From: Owczarski, Jim
Sent: Monday, September 17, 2018 8:57 AM
To: Elmer, Linda
Subject: FW: Objections to Storefront Alterations - This is not a Storefront Alteration - Changes to the Exterior of the Building

From: NEIL THOMPSON [mailto:nthompson5050@gmail.com]
Sent: Saturday, September 15, 2018 4:27 PM
To: Llelmer@milwaukee.gov; Owczarski, Jim
Subject: Objections to Storefront Alterations - This is not a Storefront Alteration - Changes to the Exterior of the Building

Proposed Site of Signage

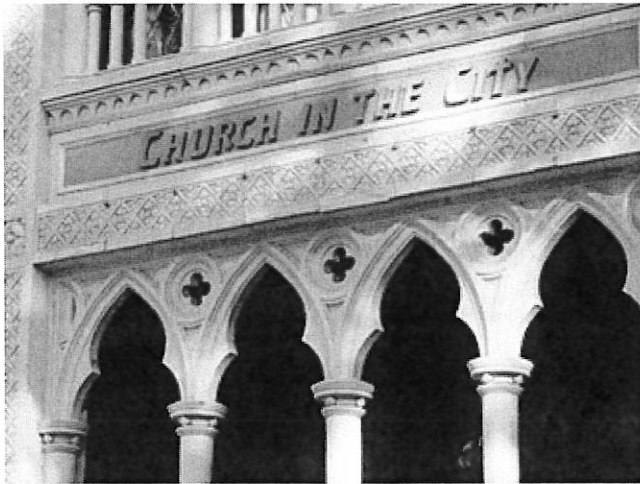
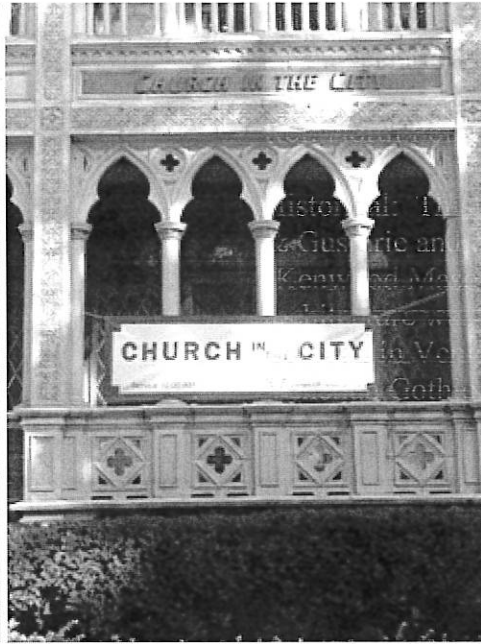
The signage proposed for the Church's raised Front Lawn of the Building Site is not located on the Building. The change for alterations is proposed for the building site, its location is not the Exterior of the Building architecture. There are other impacts, e.g., inconsistent use of materials visually (existing use of ceramic tile and brick facade vs. painted wood on posts). Impact on the pedestrian's using the public

sidewalk. Visual impact safety issue impeding views of sidewalk pedestrians from adjacent residences exiting the adjacent driveway.

My family lives next door to the Church in the Stonehenge Condominiums. The following photos were taken to illustrate the potential Visual Impact of the signage proposed for Church in the City.

Entrance Steps to Church in the City (Proposed Signage to Left of Steps in Place of Hedge?)

VISUAL IMPACT OF PROPOSED SIGNAGE:

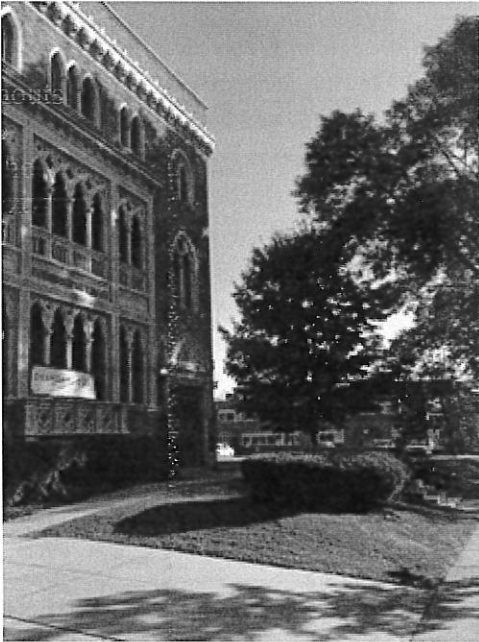
Site of Proposed Signage at the Church of the City. Advertising Church Functions/Scheduling for Pedestrian and Street levels is visually intrusive to neighborhood pedestrian (non-commercial) and will be intrusive aesthetically taking away from the historic facade of the Church and its aesthetic foundation. Clay and Ceramic Tiles and Brick (consistent with the building structure) would be a more integrated approach for such and Information Center and more in keeping with the architecture, permanent vs. an impermanent wood signage board on legs that are more consistent with temporary business and construction sites. Religious signage in front of such an historic 15th Century Architectural Facade should not be inconsistent with the building.

If the materials for the signage, instead of wood which has to be constantly maintained, were in the same architectural character as the facade of the church, the environment created would be more fitting than what has been proposed by the Church of the City. A sense of permanency in the neighborhood, as well as to the Church, is more fitting to the historic neighborhood, than cheap wooden signage, i.e., a Bulletin Board for Pedestrians or members of the church.
